GEMINI PROJECT
EA Application: Information Request

PREPARED FOR
MAGNETIC SOUTH PTY LTD

DECEMBER 2020

Table 1 Gemini Project Response to Information Request

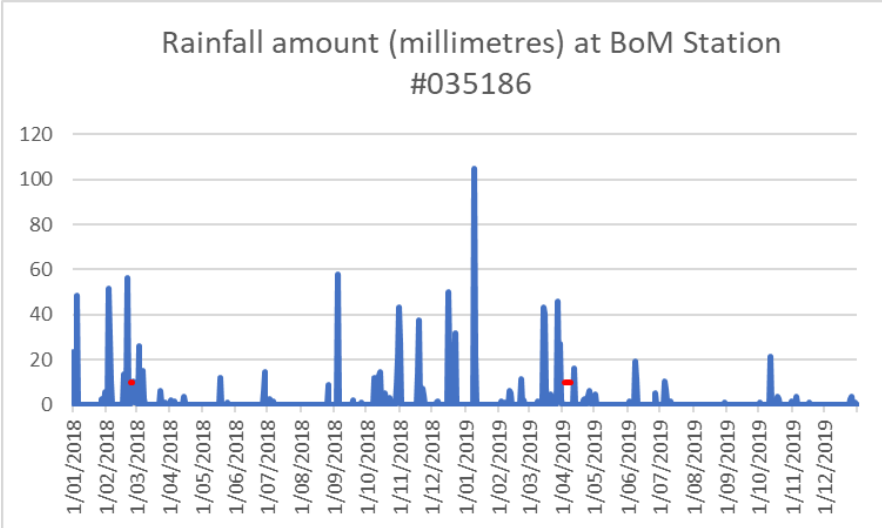
53	Appendix G Section 4.5.4 Fauna Survey Effort - Table 9	An inconsistent method of trapping/monitoring/recording has been utilised for the different seasons. For mammal trapping, 4 sites in Autumn, 6 sites in spring and 5 sites in Autumn have been selected. Why was a survey not completed in Spring 2018? The results that have been formulated do not identify animal correlation between seasons and species in the MLA as they cannot be appropriately comparable.	Justification on the amount of surveying conducted in the two different seasons over the course of the surveying period.	<p>Sections 1.1 and 4.5.4 of Appendix J to the <i>EA Application: Revised Supporting Information</i> document has been updated to provide clarification on the survey effort undertaken during the Flora and Fauna surveys. Section 1.1 of the Appendix J identifies the scope of the flora and fauna field surveys was 'to develop an inventory of terrestrial flora and fauna species inhabiting the study area, particularly species of conservation significance'. As such, field surveys were designed using the stratified sampling methods as detailed within the <i>Terrestrial Vertebrate Fauna Survey Guidelines of Queensland</i> (Eyre et al 2018) and <i>Queensland Herbarium Methodology for Survey and Mapping of Regional Ecosystems and Vegetation Communities in Queensland Version 4.0</i> (Neldner et al 2017).</p> <p>It is considered that the fauna survey effort comprehensively the addresses the objective of the field surveys described in Section 1.1 of Appendix J. This objective is to identify terrestrial fauna inhabiting the study area, particularly species of conservation significance.</p> <p>The fauna survey was planned according to the <i>Terrestrial Vertebrate Fauna Survey Guidelines for Queensland V2.0</i> (Eyre et al 2014), the current version at the time of all surveys. These guidelines state that trapping should target each habitat unit identified within the study area at least three times across the identified survey seasons. The Project is located within the Brigalow Belt bioregion, which the fauna survey guideline recommends surveying during Spring and Autumn (Eyre et al 2014). Due to access restrictions, the fauna trapping and recording took place in Autumn 2017, Spring 2017 and Autumn 2018. The <i>Terrestrial Vertebrate Fauna Survey Guidelines for Queensland V2.0</i> (Eyre et al 2014) states that '<i>...at least two surveys undertake in different seasons will be a minimum requirement...</i>'. As such, it is understood that the fauna survey guidelines requirements have been met with the three surveys, and no further survey effort was considered necessary in Spring 2018.</p>

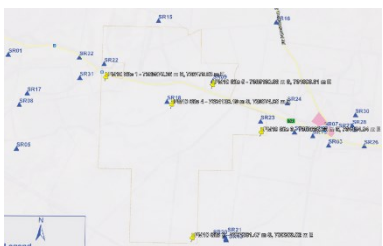
96	Appendix I Section 3.5 Air quality impact assessment	<p>Section 3.5 discussed the results produced from the air quality modelling.</p> <p>Each of the subsections within Section 3.5 stated that “using standard, and when necessary, additional mitigation</p>	<p>Update the air quality model, and results, to reflect the NPI manual.</p> <p>Describe in detail the mitigation measures to be</p>	<p>Refer to issue number 95 regarding the emission reduction factor used and the feasibility of the proposed mitigation measures.</p> <p>Similarly, refer to Appendix B (Surface Water Assessment) of the <i>EA Application: Revised Supporting Information</i> document that demonstrates adequate amounts of water will be available to meet the water demand for the proposed dust suppression.</p>

Issue No.	EA Application Chapter /Section	Regulator Comment	Information Requirement	Magnetic South Response
		<p>measures predicted 24-hour average and annual average concentrations of PM₁₀ comply with relevant air quality objectives at all sensitive receptors. Additional mitigation measures may include restricting overburden and ROM haul to between 7am and 6pm on days when 24-hour averaged maximum PM₁₀ is predicted to exceed 50 µg/m³."</p> <p>Table 5, Section 3.4.2, stated that an 85% reduction factor for hauling of ROM coal and hauling of overburden has been applied. The National Pollutant Inventory Emission Estimation Technique Manual for Mining (NPI manual) only allows 50% for level 1 watering (2 litres/m²/hr) and 75% for level 2 watering (>2 litres/m²/hr). As such, the department considers that the modelled results are significantly underestimated.</p> <p>No further information has been provided in relation to which mitigation measures were applied in the model or in which instances that these mitigations are likely to be applied.</p>	<p>applied to mitigate impacts to air quality resultant from the Gemini Coal Project, including an assessment of the feasibility of the mitigation measures in application.</p> <p>Provide information to confirm that adequate amounts of water will be available to meet the water demand for the higher rate of watering required for the Level 2 rate of greater than 2 litres/m²/hr.</p>
